DATE ISSUED 04.17.2026

ADDENDUM # 2

PROJECT Wayne State College Cooling Tower Replacement

ETI PROJECT # 2025-134

**A2 MECHANICAL DEMOLITION PLAN**  
1/4" = 1'-0"

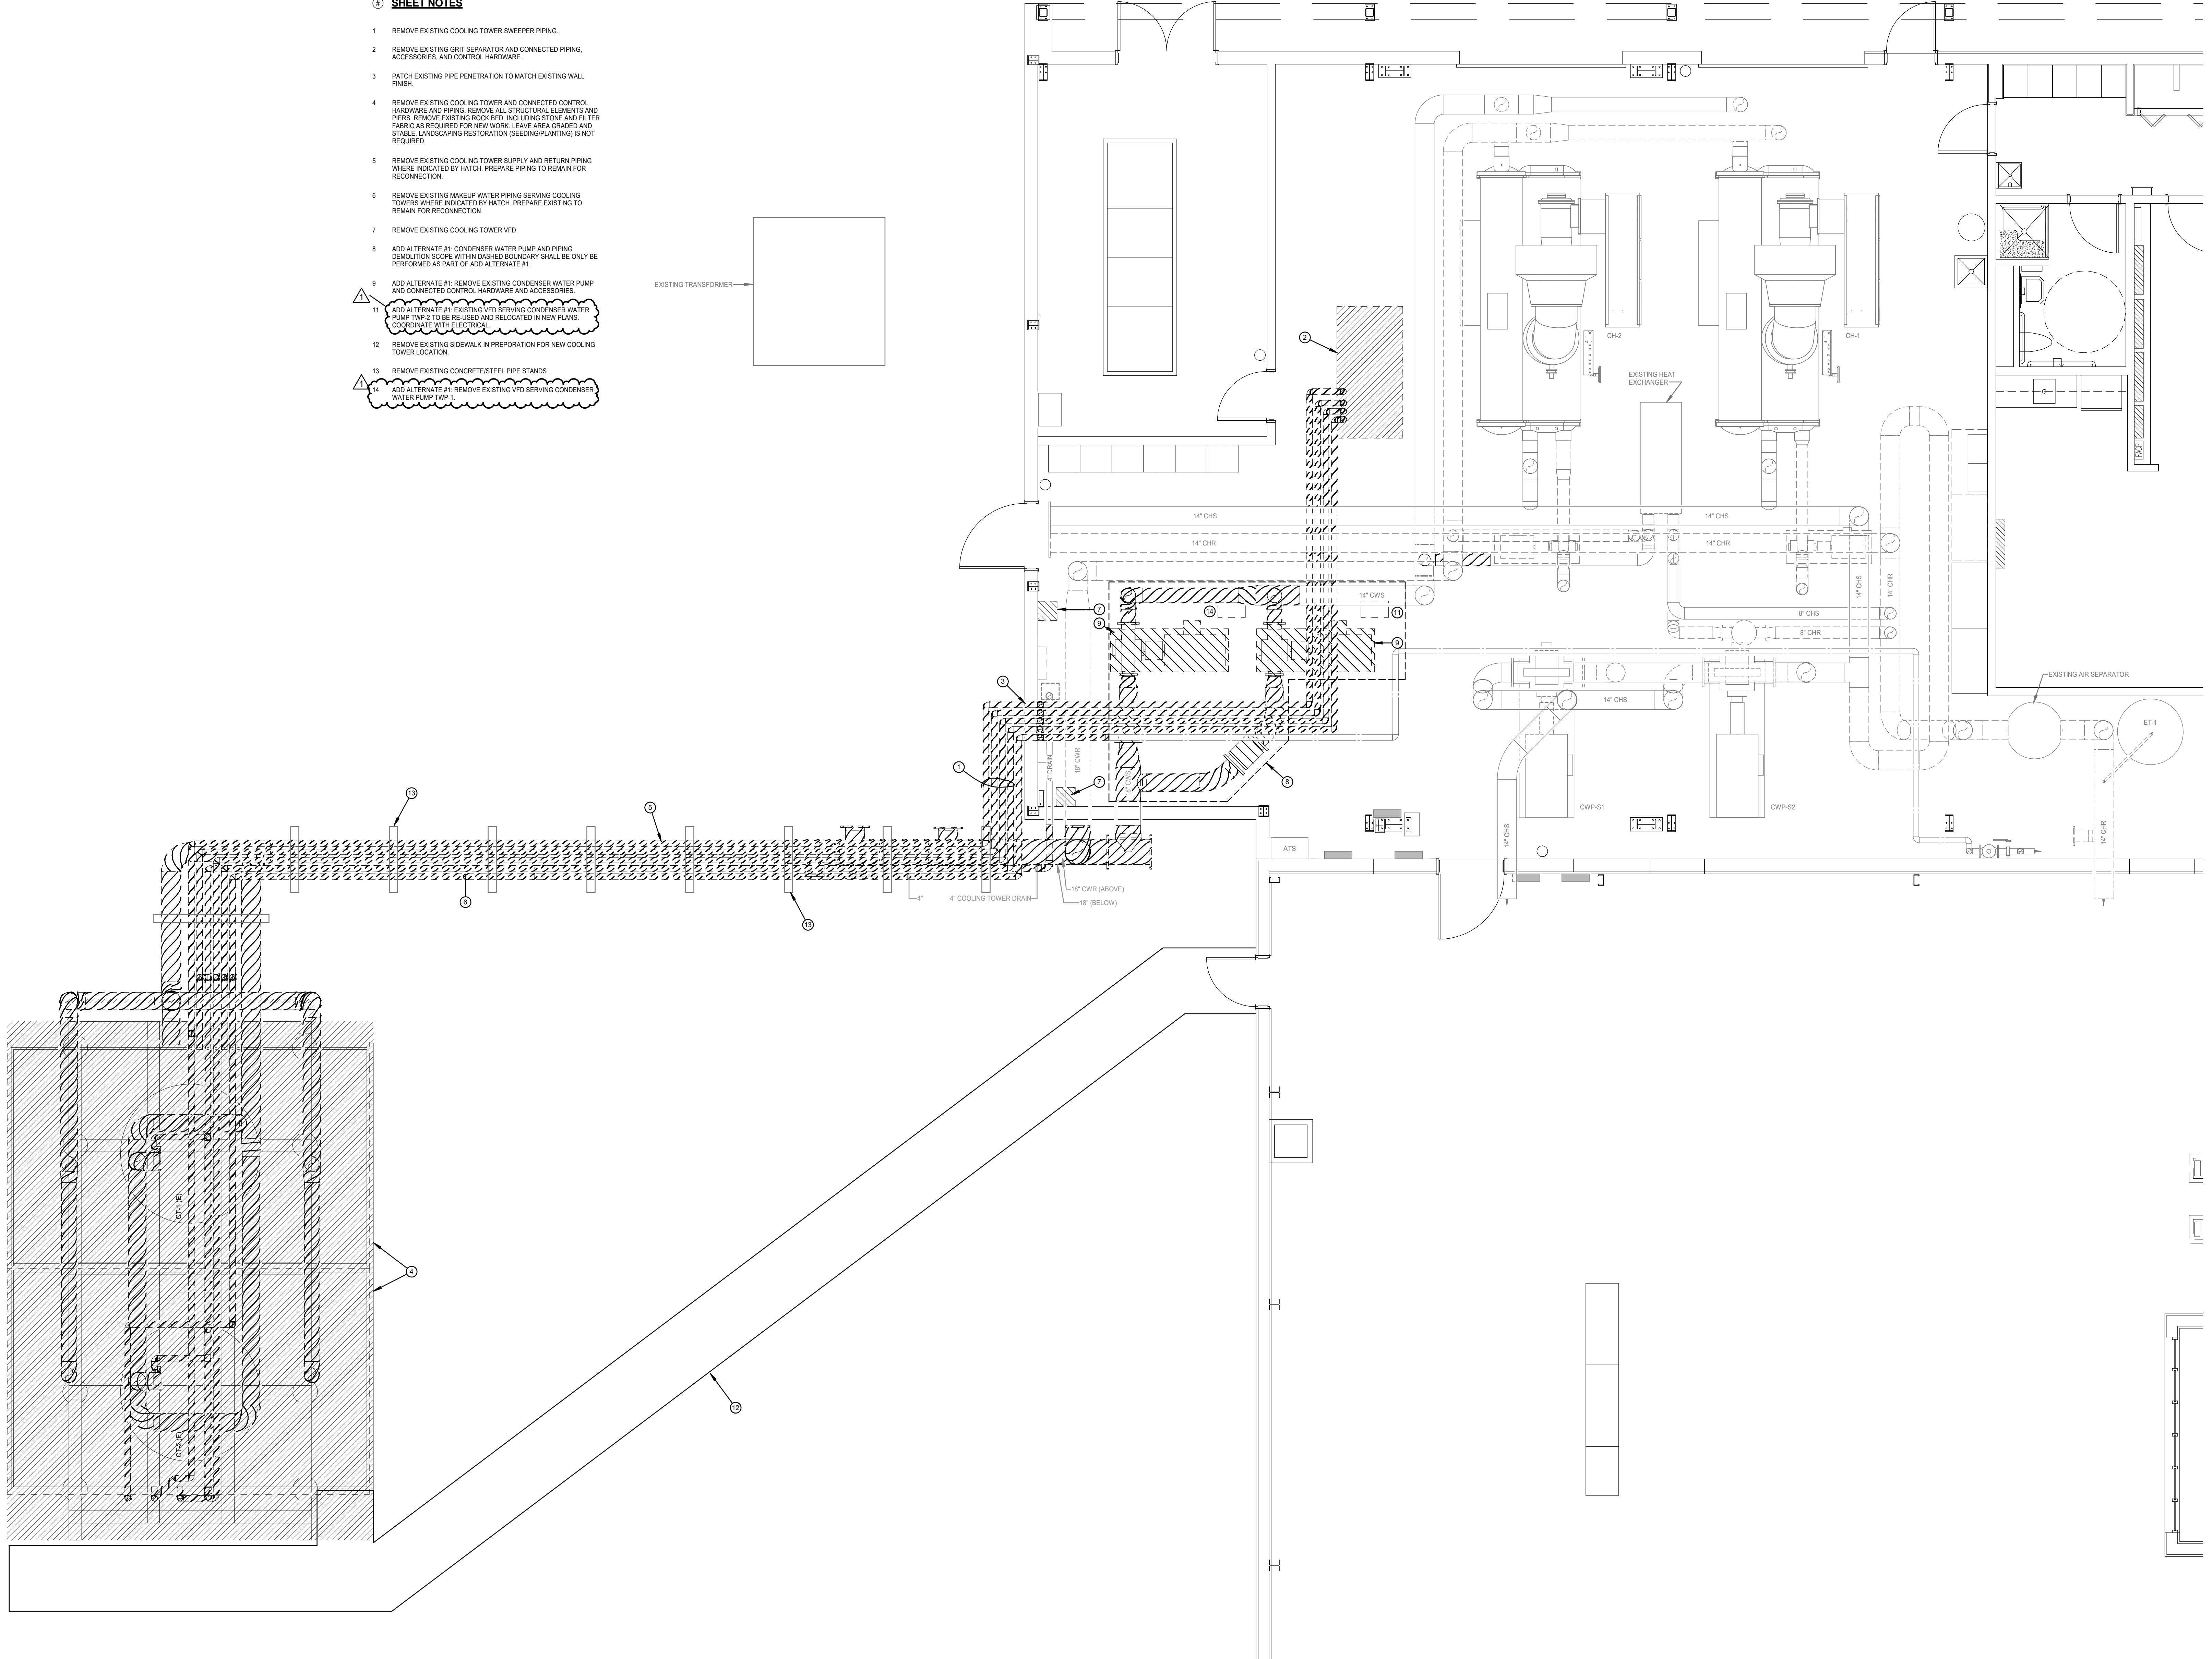
- 1. Sheet MD1.1 – Mechanical Demolition Plan
A. Modified Alternate #1 to only reuse one of the existing VFDs serving TWP-2. The VFD serving TWP-1 will be demolished.
2. Sheet M1.1 – Mechanical Plan
A. Modified Alternate #1 to only reuse one of the existing VFDs serving TWP-2. A new 75-HP VFD will be provided to serve TWP-1.
B. Clarified sheet notes.
3. Sheet M3.1 – Mechanical Schedules
A. Revised VFD schedule to have the VFDs provided with Bypasses.
B. Added VFD-TWP-1 to the schedule.

- 7 REMOVE EXISTING COOLING TOWER VFD.
- 8 ADD ALTERNATE #1: CONDENSER WATER PUMP AND PIPING DEMOLITION SCOPE WITHIN DASHED BOUNDARY SHALL BE ONLY BE PERFORMED AS PART OF ADD ALTERNATE #1.

- 9 ADD ALTERNATE #1: REMOVE EXISTING CONDENSER WATER PUMP AND CONNECTED CONTROL HARDWARE AND ACCESSORIES.
- 10 ADD ALTERNATE #1: EXISTING VFD SERVING CONDENSER WATER PUMP #2 TO BE REUSED AND RELOCATED IN NEW PLANT. COORDINATE WITH ELECTRICAL.

- 11 REMOVE EXISTING SIDEWALK IN PREPARATION FOR NEW COOLING TOWER LOCATION.
- 12 REMOVE EXISTING CONCRETE/STEEL PIPE STANDS.
- 13 ADD ALTERNATE #1: REMOVE EXISTING VFD SERVING CONDENSER WATER PUMP #1.

**A5 ELECTRICAL PLAN**  
 1/4" = 1'-0"

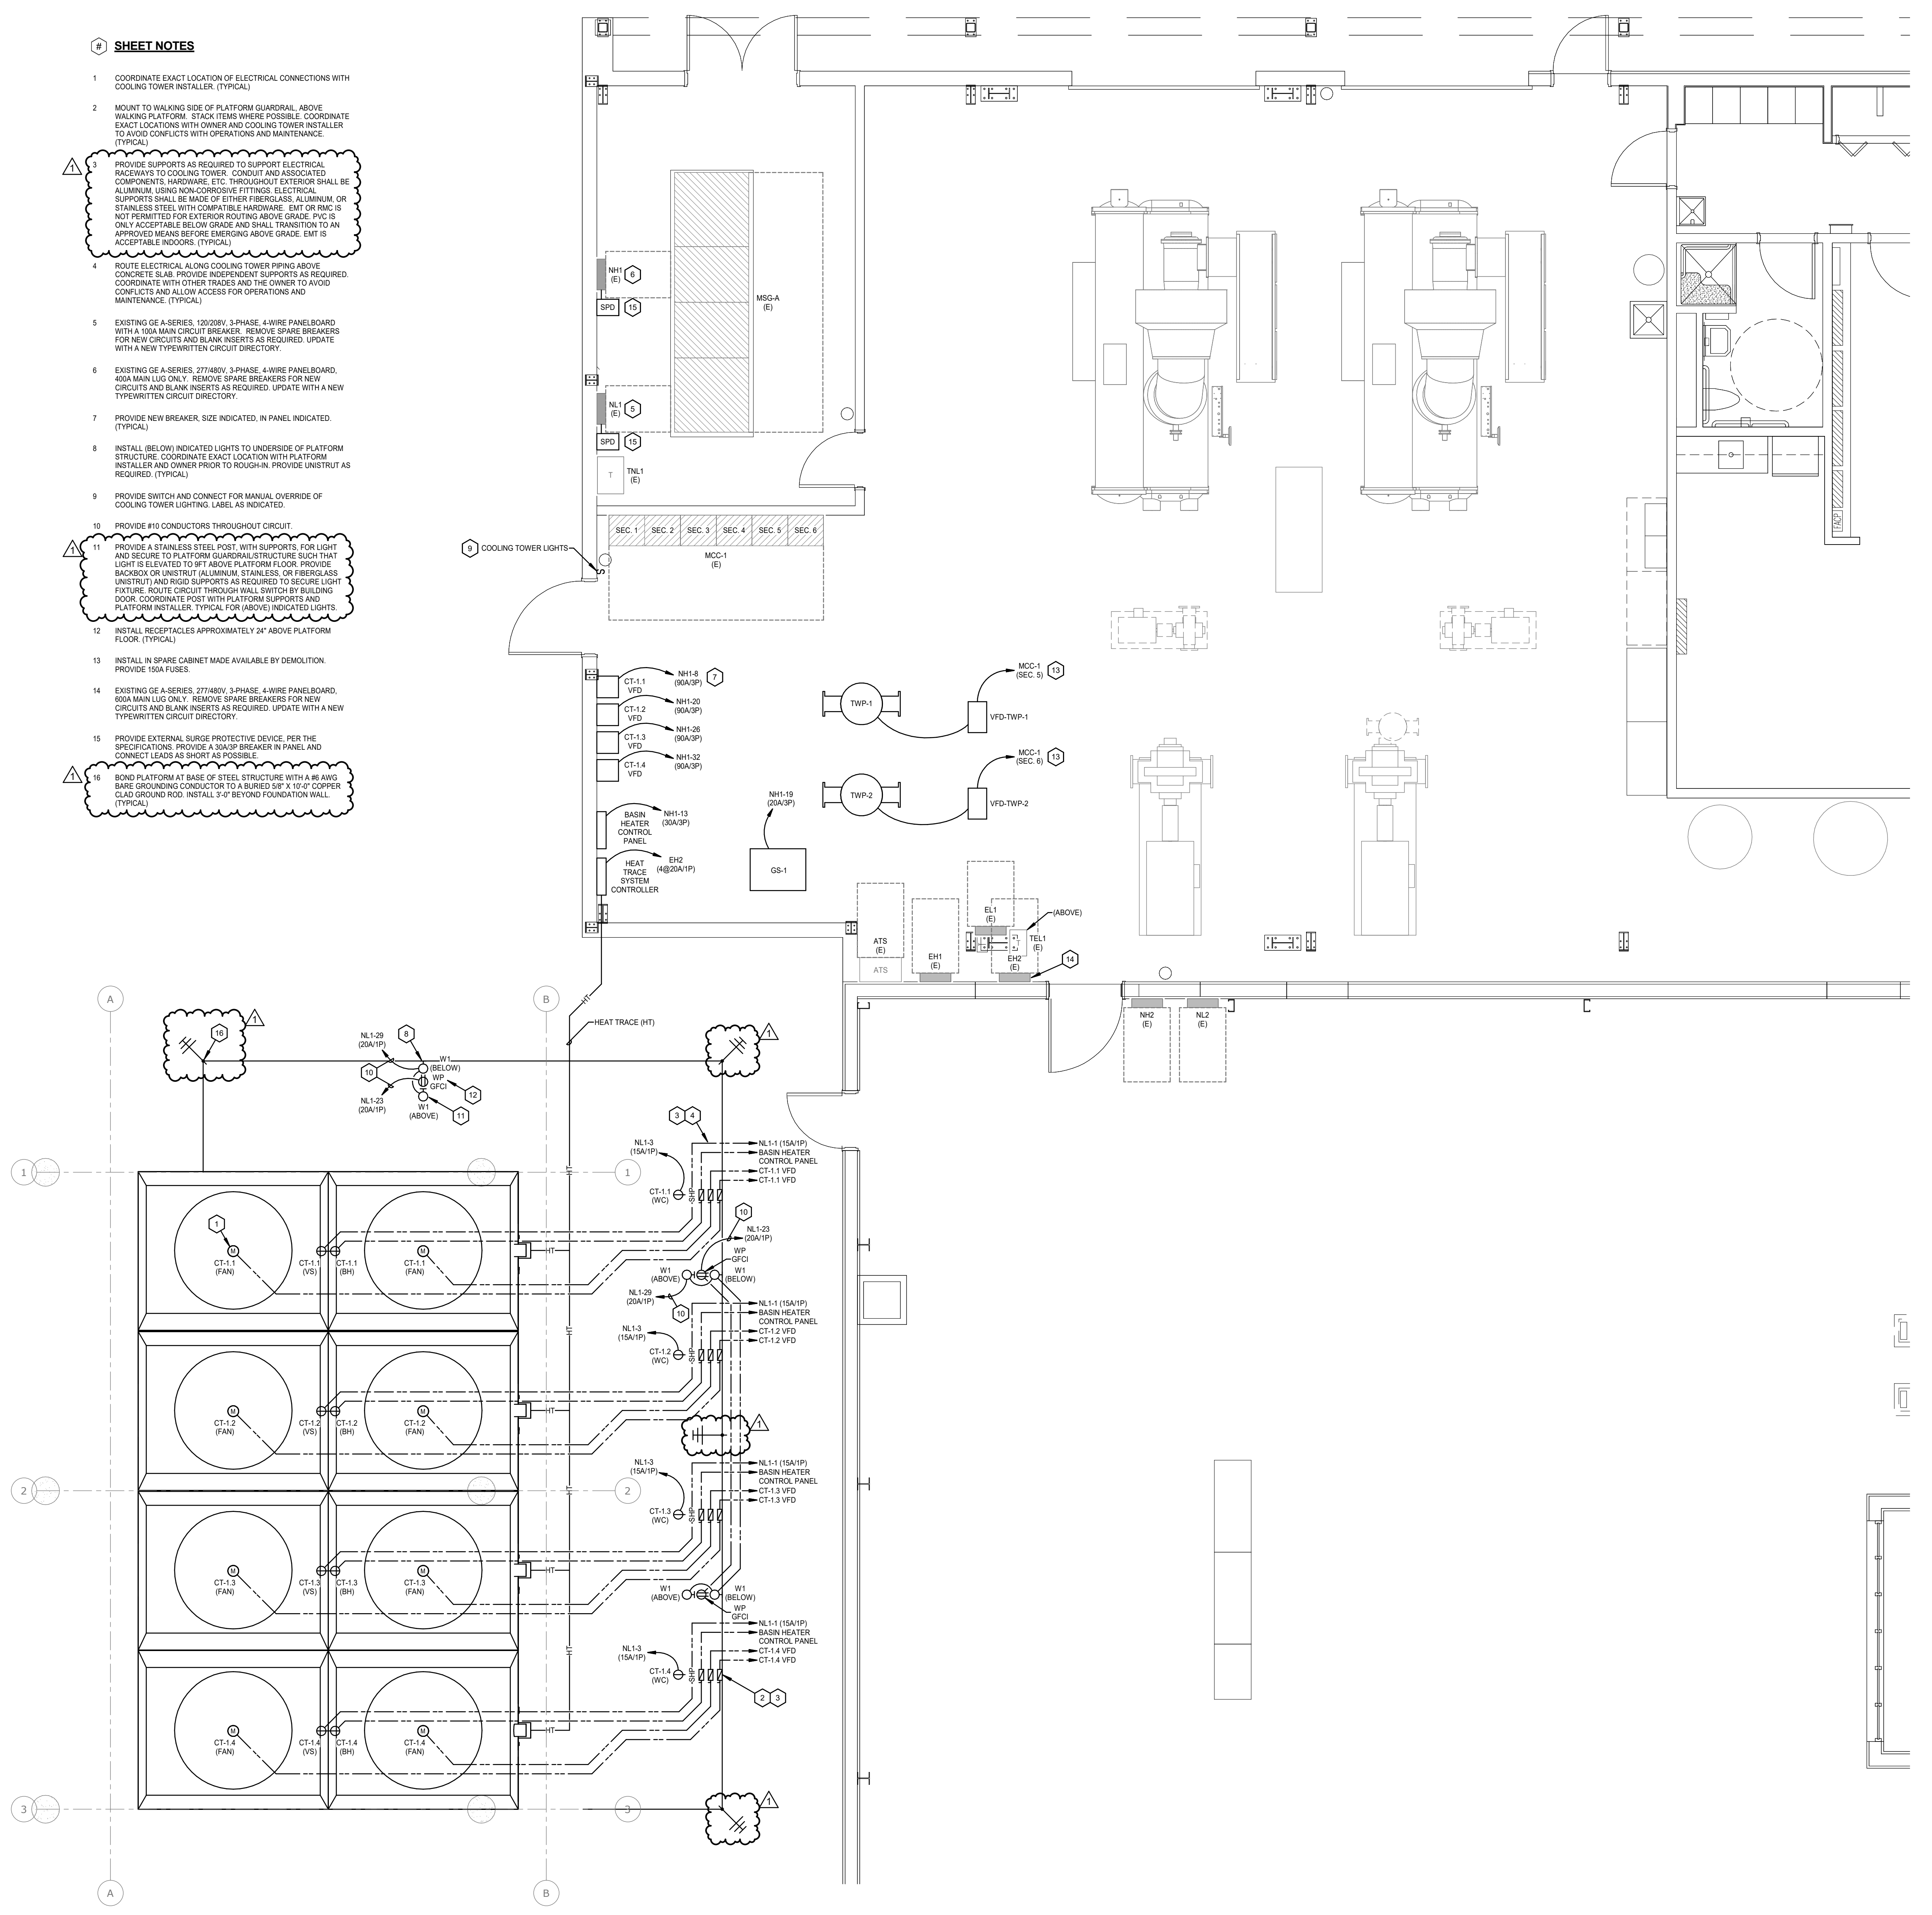
- 1. Sheet EG0.0 – Electrical General Information
A. Modified CT-1.1 (FAN), CT-1.2 (FAN), CT-1.3 (FAN), and CT-1.4 (FAN) Safety Switches.
B. Modified CT-1.1 (FAN), CT-1.2 (FAN), CT-1.3 (FAN), CT-1.4 (FAN), TWP-1, and TWP-2 Remarks.
2. Sheet E1.1 – Electrical Plan
A. Modified sheet notes #3 and #11.
B. Add sheet note #16 to provide bonding requirements.

- PROVIDE EXTERNAL SURGE PROTECTIVE DEVICE, PER THE SPECIFICATIONS. PROVIDE A 300A BREAKER IN PANEL AND CONNECT LEADS AS SHOWN AS POSSIBLE.
- BOND PLATFORM AT BASE OF STEEL STRUCTURE WITH A 6 AWG BARE GROUNDING CONDUCTOR TO A BURIED SFP X 1/2" COPPER CLAD GROUND ROD. INSTALL 3'-0" BEYOND FOUNDATION WALL. (TYPICAL)
